**RE: NARRABRI UNDERGROUND MINE STAGE 3 EXTENSION PROJECT – IESC AND DPIE–WATER RESPONSES AND GROUNDWATER MONITORING CLARIFICATIONS**

**ATTACHMENT 1**  
**RESPONSE TO IESC SUBMISSION**

**Figure A1-1**  
**Transient Calibration – Modelled vs Observed Groundwater Levels, Namoi Alluvium (Source: AGE [2021])**

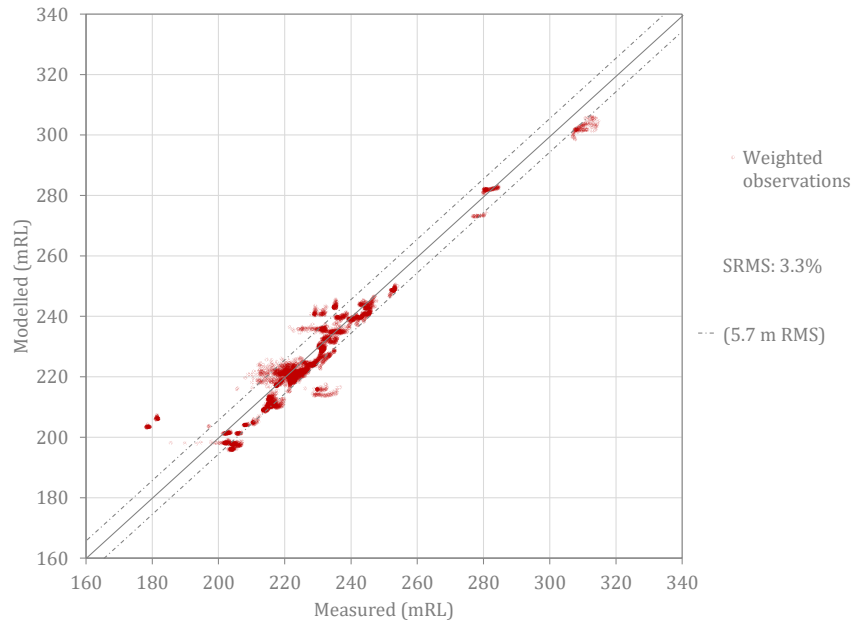
- a. *The groundwater model presented in the Gateway application has been revised, with the proponent undertaking additional work to address many of the issues raised in previous IESC advice. The groundwater modelling provided by the proponent presents extensive steady-state and transient 3D numerical groundwater models accompanied by a stochastic uncertainty quantification of simulated model outputs (AGE 2020, App D, p.12), which have undergone independent peer-review. However, the IESC does not consider that all relevant parameters (e.g. hydraulic conductivity and storativity) and boundary combinations have been considered in the proponent's assessment of potential impacts, which may result in an underestimate of potential impacts. Evidence of this potential underestimate is seen in the reported model-to-measurement misfits, where the calculated range of uncertainty of the modelled groundwater levels does not encompass the actual measured values (AGE 2020, App D, p. 2).*

Consistent with its stated aim, the model does not seek to exactly match system stresses and other hydrogeological features which affect groundwater levels but which have little or no bearing on the ability of the model to predict impacts. For instance, groundwater level data are available for over 100 monitoring bores completed into the Namoi Alluvium and have been used for calibration of the numerical model. As shown in Figure A1-1, the overall statistical fit to these data is very good, as evidenced by the scaled root mean square (SRMS) error of 3.3 percent (%), which suggests that the overall model parameterisation of the Namoi Alluvium is appropriate.

Figure A1-5

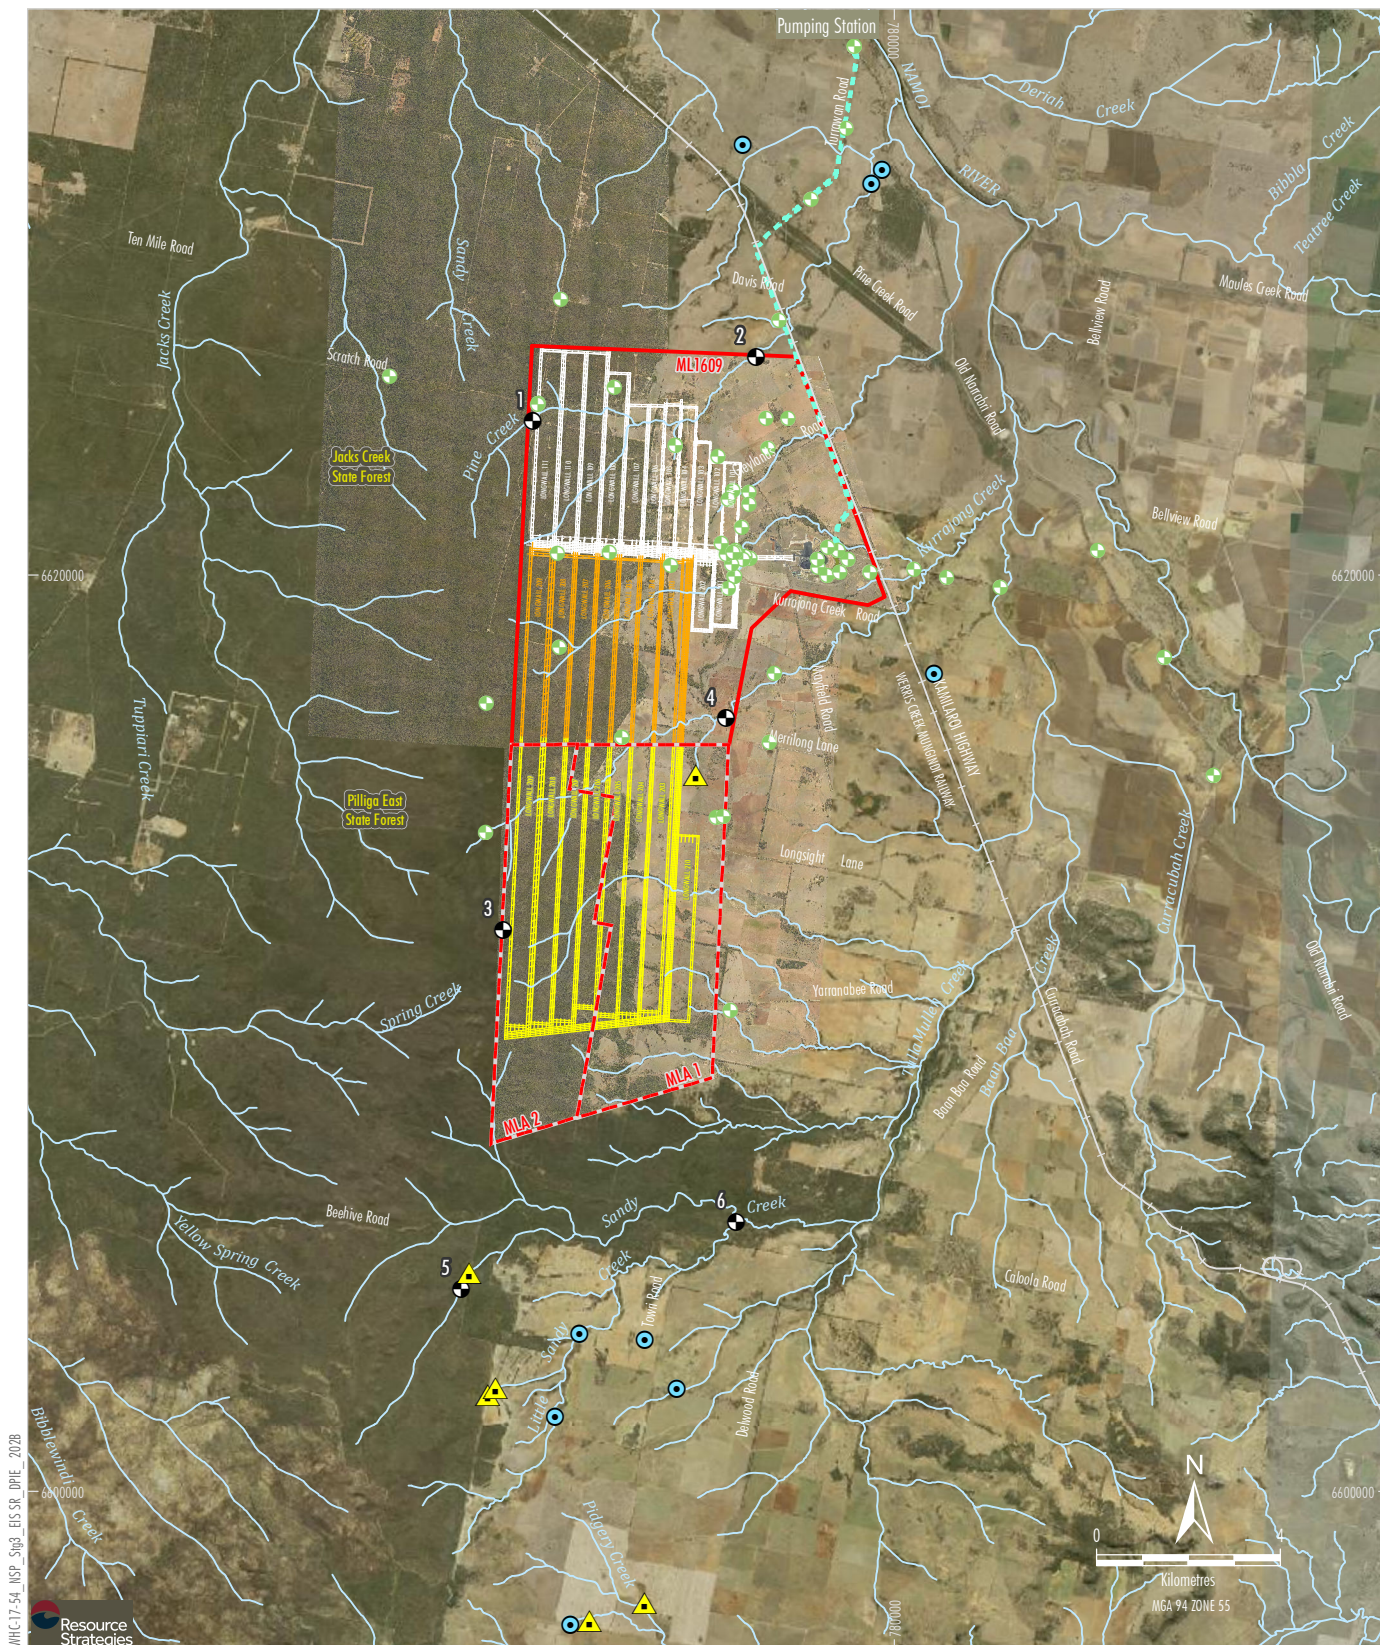
- d. *Noting some of the rapid depressurisation of groundwater resources predicted in the EIS groundwater assessment, the groundwater model should be bi-annually updated as works progress at the site. More extensive regional monitoring of the Purlawaugh, Napperby and Digby Formations along with the Garrawilla Volcanics would provide a better indication of hydrostratigraphic unit interaction, and provide the evidence required to explain why the proponent has observed depressurisation in many of these groundwater sources. Updating of the model based on further monitoring of groundwater levels in the area above the longwalls would refine the assessment of the impact on regional groundwater fluxes caused by the increasing vertical hydraulic conductivity in that area (Paragraphs 12, 22).*

A subsidence calibration borehole would also be established within the Stage 3 Project mining areas (nominally within Longwalls 203 or 204). In addition, as shown in Figure A1-5 since a number of the existing sites are above proposed longwall panels (and proposed sites in near proximity to the longwall panels) this will also provide additional data on mining impacts. This data would then be used to re-calibrate the model and hence also ultimately address IESC Submission 6 which calls for the use of more site-specific data above longwall panels. More detail is provided in Attachment 4 of this letter.

As discussed in the Response to Comment 3d above, additional groundwater monitoring is proposed at six locations shown in Figure A1-5. Each site would comprise standpipe monitoring bores installed into the Quaternary alluvium and immediately underlying bedrock and VWP nests monitoring groundwater levels in underlying units. These additional facilities would be installed as soon as possible after approval is received such that they could provide significant additional groundwater level data into a refinement of the groundwater model to be completed within two years of approval.

**Figure A1-6**  
**Approved and Project Longwall Panels and High Priority GDE Sites where Predicted Maximum Drawdown Exceeds 5m**

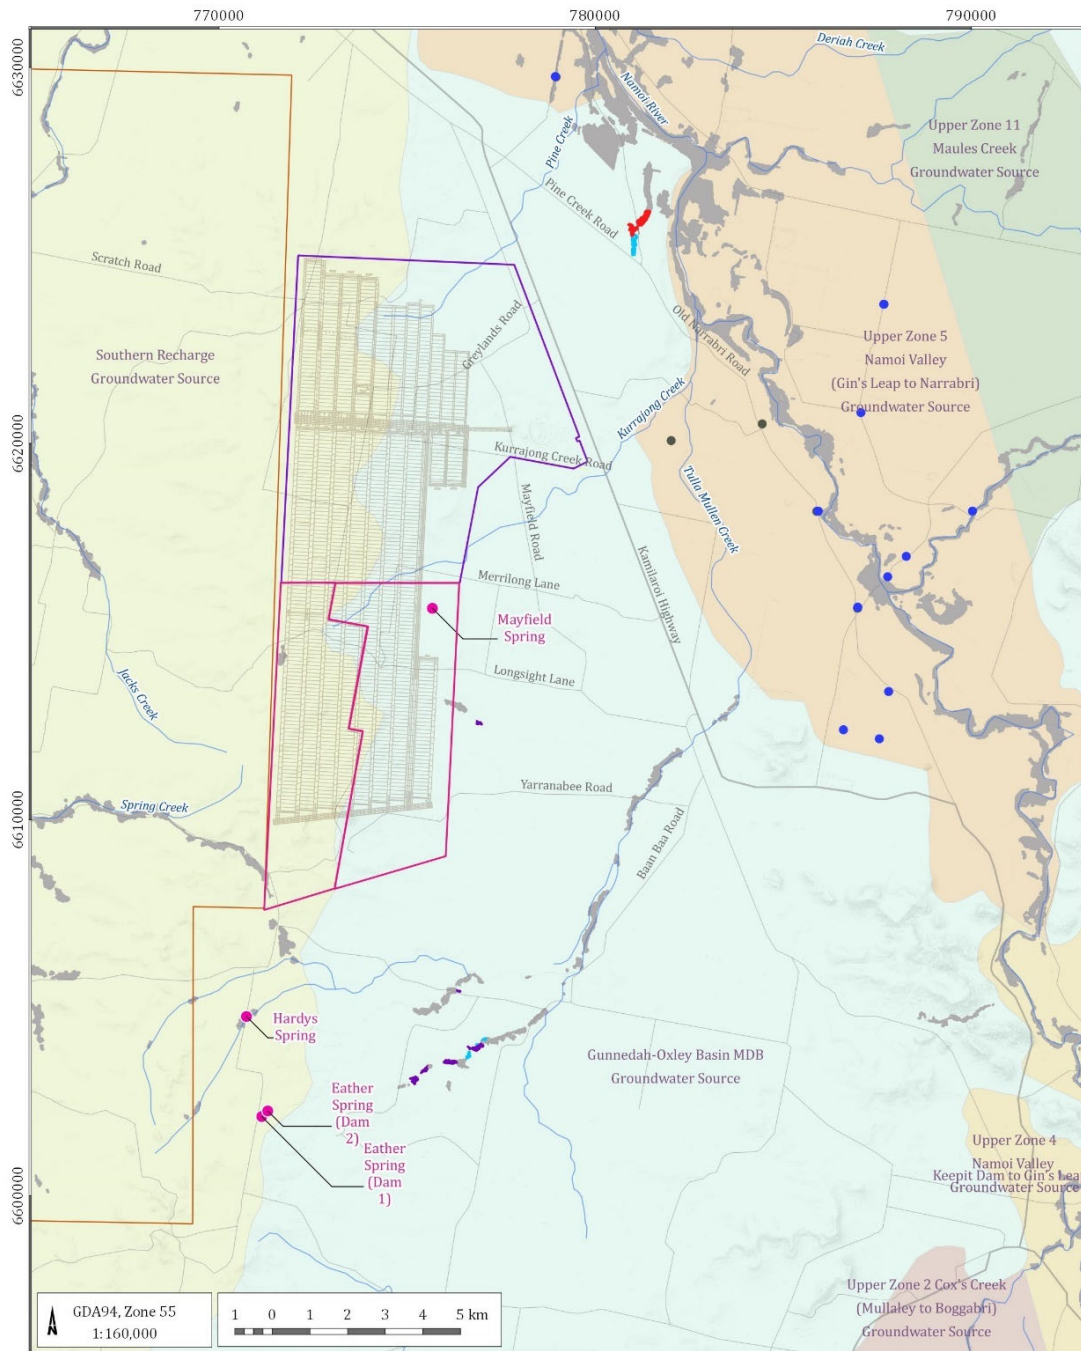
6. *The effects of drawdown on vegetation are dismissed as 'minor impacts' (Resource Strategies 2020, p. 103), despite drawdown in many areas being predicted to be 10-20 m. Even in areas where the water is only 2 m below ground level before drawdown, this amount of drawdown is likely to severely impact groundwater-dependent vegetation. Such impacts potentially disrupt vegetated corridors and impair or remove vital habitat for native fauna and flora. The claim that mining-induced changes in groundwater level will be gradual and lie within predicted ranges does not preclude the likelihood that the rates of drawdown will be greater than the ability of the root systems to maintain contact with the water table. Further, when drawdown peaks (estimated as some 150 years post-mining), groundwater levels below many of these terrestrial GDEs may be too low to ameliorate the effects of other stressors such as prolonged drought and dieback.*

Figure A1-6 shows the location of high priority GDE areas in relation to the approved and Stage 3 Project longwall panels. GDEs where predicted maximum drawdowns exceed 5 m are shown shaded based on the GDE type, other GDEs where maximum impacts of less than 5 m are predicted are shown shaded grey. As shown in this map no GDEs are mapped in areas overlying longwall panels. Maximum impacts of more than 5 m are predicted at a small number of GDE polygons to the east and south-east of the Stage 3 Project area. Further assessment of the potential ecological impacts of these predicted drawdowns on GDEs is provided in Section 6.19 of the EIS. Potential impacts on fauna are discussed in Response to Comment 14.

**Figure A1-7**  
**Daily flow duration curve, Bohena Creek at the Newell Highway (GS419905)**

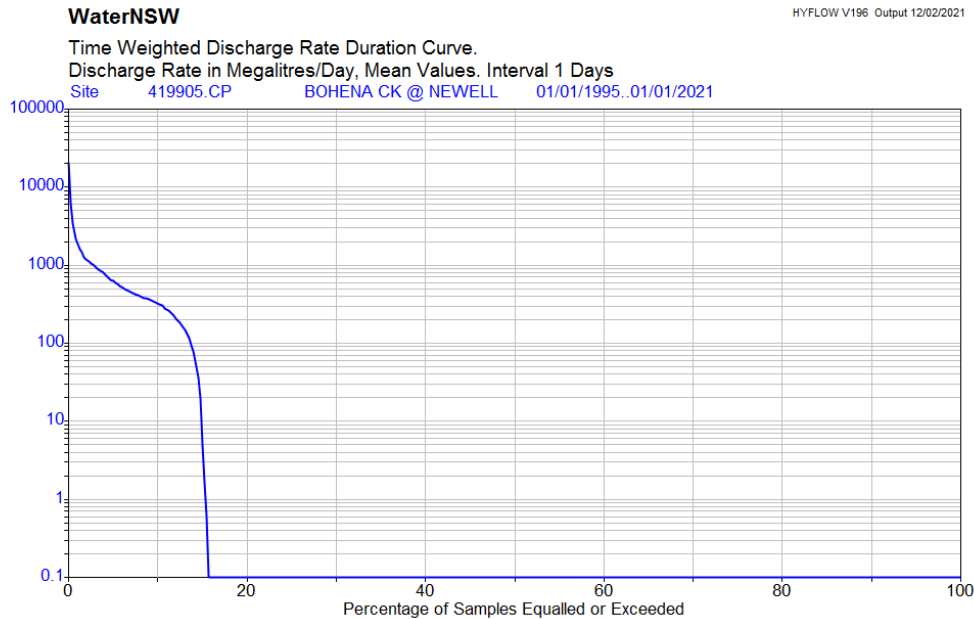
25. *There is little to no confidence in the predictions of the lack of baseflow in the ephemeral tributaries as no modelling or monitoring has been completed or planned to be completed.*
- a. *Clarification is required to determine if streams are predominately gaining or losing to determine their groundwater dependence (OWS 2020, p. 6-7).*

Further evidence of the lack of baseflow is shown in Figure A1-7, which is a ranked plot of the recorded daily flows at the WaterNSW stream gauge on Bohena Creek at the Newell Highway (GS410905). Although the Bohena Creek catchment is much larger, its flow characteristics are expected to be similar to the site catchments because it drains the Pilliga State Forest and has similar soil and vegetation characteristics as the upper headwaters of the site catchments. Figure A1-7 shows that Bohena Creek flowed on about 15% of days and there is little to no baseflows, which for Bohena Creek could be considered the flows less than 100 megalitres per day (1.1 cubic metres per second). This is also supported by the environmental assessment undertaken for the Narrabri Gas Project (Santos Ltd, 2015), which determined that Bohena Creek is a ‘losing’ stream that loses water to the perched alluvial aquifer.

**Figure A2-1**  
**Likelihood of 2 m drawdown due to the Stage 3 Project – Quaternary Alluvium/Regolith**

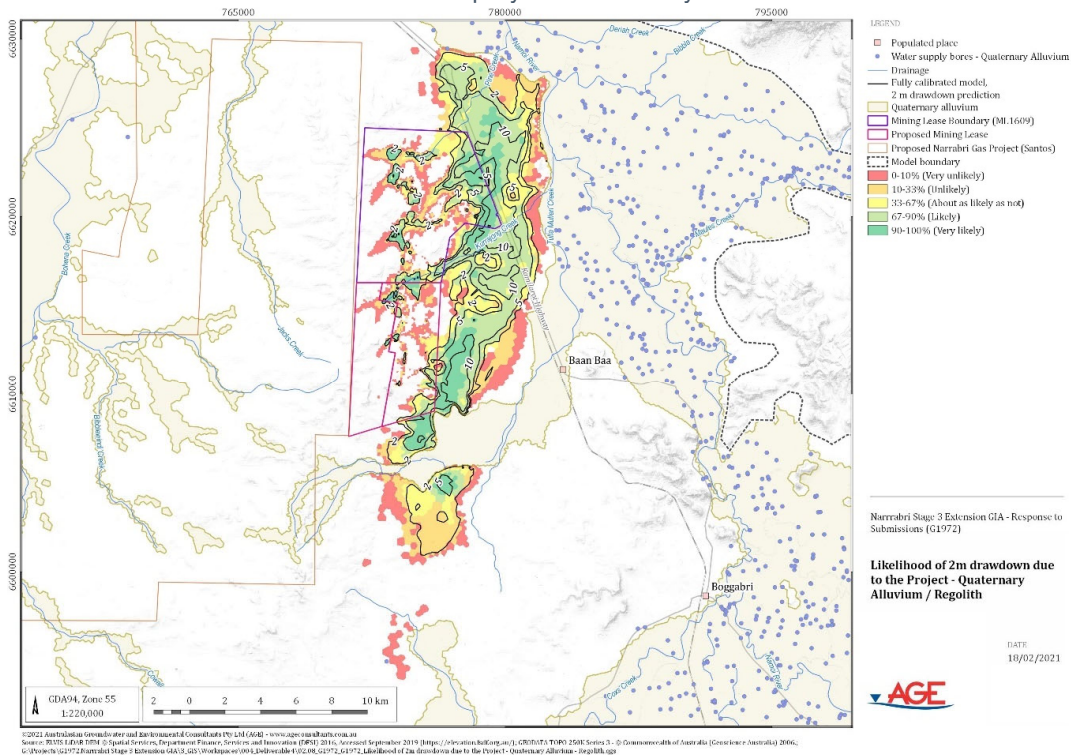
- The project's dewatering requirement results in a maximum drawdown which closely matches the Aquifer Interference Policy (AIP) minimal impact consideration threshold of 2 metres at the boundary of the Namoi Alluvium. (Refer to Figure 1 in Appendix B). Therefore, predicted drawdowns at all bores accessing "highly productive" water sources are within the AIP minimal impact criteria.

As described in Appendix D (Section D 5) of the Groundwater Assessment (AGE, 2020) the sensitivity of model predictions to parameter uncertainty has already been assessed via completion of a predictive uncertainty analysis. Hence in addition to the 'best estimate' predictions of drawdown in Quaternary Alluvium/regolith drawdowns shown in Figure 7.8 of the Groundwater Assessment and predictions for a further 100 realisations can be analysed statistically to assess the likelihood of the 2 m drawdown contour extending further onto the Namoi Alluvium. The results of this statistical analysis are presented in Figure A2-1. A very similar plot was presented in the Appendix D of the Groundwater Assessment but has been revised for clarity to show drawdown in model layer 1 (i.e. the Quaternary Alluvium/regolith) rather than at the water table. As shown in Figure A2-1, uncertainty analysis results suggest that impacts of more than 2 m are very unlikely to occur within the Namoi Alluvium at any point in the future. This is because the indirect loss of groundwater from the base of the alluvium to the depressurised underlying Permian strata is less than the recharge rate to the alluvial groundwater system for all of the model realisations. The unconsolidated nature of the Namoi Alluvium means that it is characterised by substantially higher recharge, hydraulic conductivity and storage properties than the underlying consolidated Permian strata such that the relatively minor drawdowns predicted towards the limit of the Permian strata reduce rapidly at the boundary of the alluvium.
